## **Amendment #1 -- Farrington Road**

**Durham-Chapel Hill-Carrboro Metropolitan  
Planning Organization**  
Comprehensive Transportation Plan  
September 12, 2018

## DCHC MPO -- Amendment #1

Draft Leigh Village roadway network  
July 2018

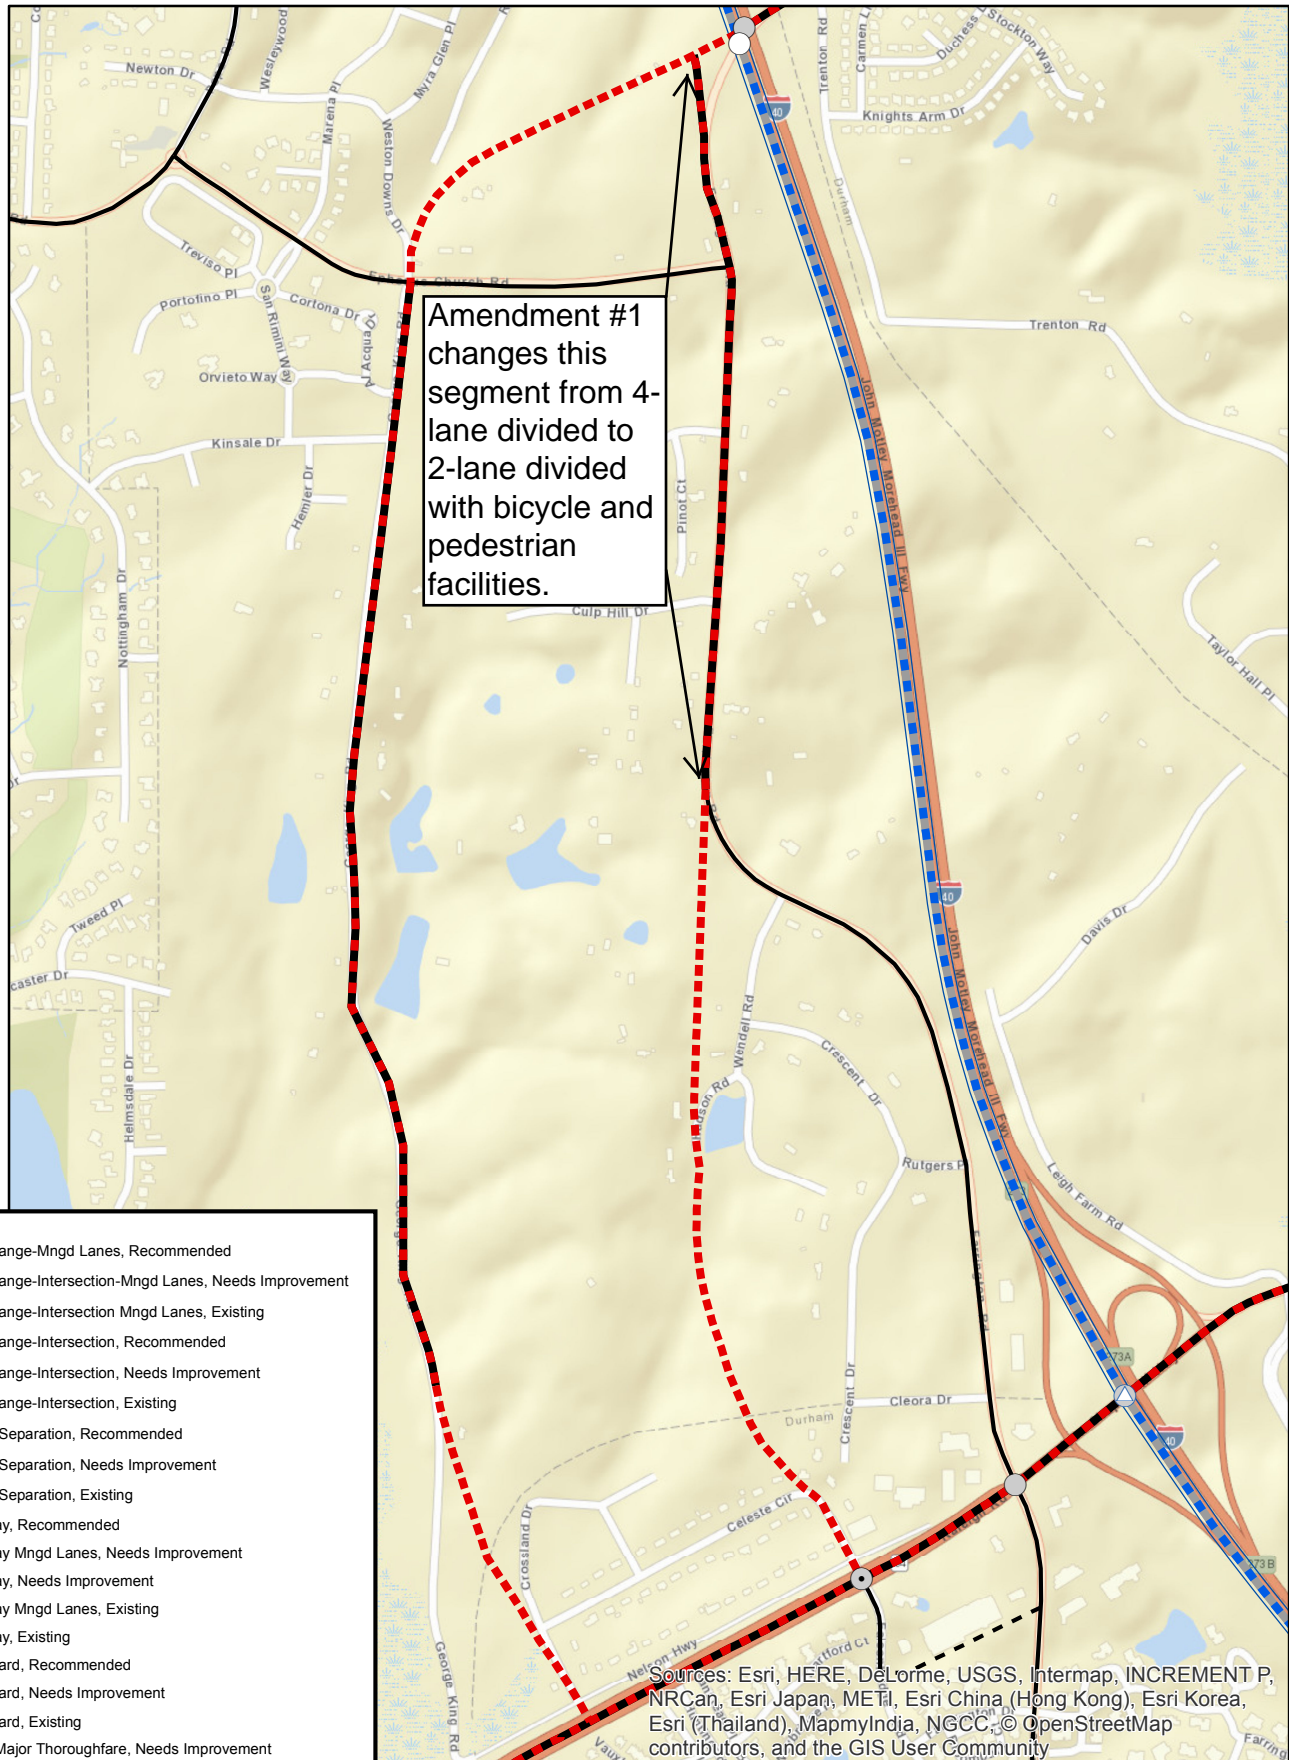
The Durham-Chapel Hill-Carrboro Metropolitan Planning Organization (DCHC MPO) hereby amends the Comprehensive Transportation Plan (CTP) to change the proposed future configuration of the segment of Farrington Road between Southwest Durham Drive and the Falconbridge Road Extension. The originally adopted CTP lists this roadway segment as a future four-lane, divided cross-section. Amendment #1 changes the cross-section to be a two-lane, divided cross-section with bike lanes and sidewalks. The CTP highway map on page 4 shows the roadway segment that is to be amended. A larger, interactive map can be found at the top of the following CTP Web page: [www.bit.ly/DCHCMPO-Adopted-CTP](http://www.bit.ly/DCHCMPO-Adopted-CTP)). Note that the CTP uses a distinct name, i.e., boulevard, and map symbology for divided roadways.

The MPO believes that a two-lane, divided cross-section that includes bicycle and pedestrian facilities is more appropriate for forecasted traffic volume in that corridor and the future, adjacent land use. The map on page 5 depicts the likely future roadway network in the so-called Leigh Village area where a Durham-Orange Light Rail Transit station is planned, and shows the capacity and forecasted traffic volumes on the two north/south arterial boulevards. The 2045 traffic volume forecast for Farrington Road, 16,000 to 22,000vpd (vehicles per day), might exceed the two-lane divided capacity, 18,000vpd. However, the Southwest Durham Drive capacity, 18,000vpd, will significantly exceed the 2045 traffic volume forecast, 8,000vpd. These two roads are parallel and will be connected by local roads and collector roads stipulated in the *Southwest Durham/Southeast Chapel Hill Collector Street Plan*. If vehicle traffic becomes congested on Farrington Road, traffic can easily divert to the Southwest Durham Drive that has excess capacity.

2045 volume: 8,000  
2-lane divided capacity: 18,000

2045 volume: 16,000 to 22,000  
2-lane divided capacity: 18,000  
2-lane capacity: 13,000

Appendix C, Street Inventory -- The table below shows the current and proposed amendment #1 attributes for this segment of Farrington Road in the CTP. The change is shown in **bold blue** font – the cross section will be 2L (2-lane, divided with bicycle and pedestrian facilities). Note that the original CTP report used the 2040 forecasts from version 5 of the Triangle Regional Model (TRM). The MPO analysis for this amendment uses the updated TRM, i.e. version 6, and therefore the analysis and CTP report forecasts values might vary slightly.

Highway												
ID	Facility	Segment		Dist. (mi)	Lanes	2015 Existing System		2040 Proposed System				CTP Class
		From	To			Existing Capacity (vpd)	2011 Volume	2040 Volume E+C	2040 V/C	Status	Cross-Section	
Current CTP...												
DURH0039-H	Farrington Rd	Falconbridge Ext.	Southwest Durham Dr	0.8	2	12,700	11,000	23,200	1.80	NI	4D	Blvd
Amendment												
DURH0039-H	Farrington Rd	Falconbridge Ext.	Southwest Durham Dr	0.8	2	12,700	11,000	23,200	1.80	NI	<b>2L</b>	Blvd
